From: Gonzalez, Luis <LGonzalez@claytonwilliams.com>
Sent: Tuesday, May 3, 2016 6:02 PM
To: Bratcher, Mike, EMNRD; Randall Hicks
Cc: Gonzalez, Luis; mike@rthicksconsult.com; 'Chris Northcutt'; Patterson, Heather, EMNRD; Billings, Bradford, EMNRD
Subject: RE: Clayton Williams Jenna

From: Randall Hicks [mailto:r@rthicksconsult.com]
Sent: Tuesday, May 03, 2016 3:18 PM
To: Bratcher, Mike, EMNRD
Cc: 'Gonzalez, Luis'; mike@rthicksconsult.com; 'Chris Northcutt'
Subject: Clayton Williams Jenna

BH-7 Cl v. Depth

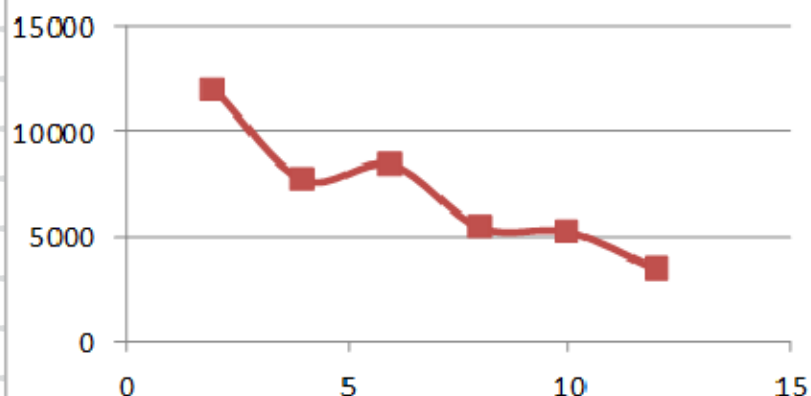
We will start drilling the test borings on Thursday morning. We begin with a 110 foot hole near the southwest trench that showed the following chloride data:

This trench is between trenches B-7, 8 and 9 on the attached figures. Here is what these trenches look like:

The data allow me to predict that we will see near background chloride levels about 20 feet below grade at this deep boring
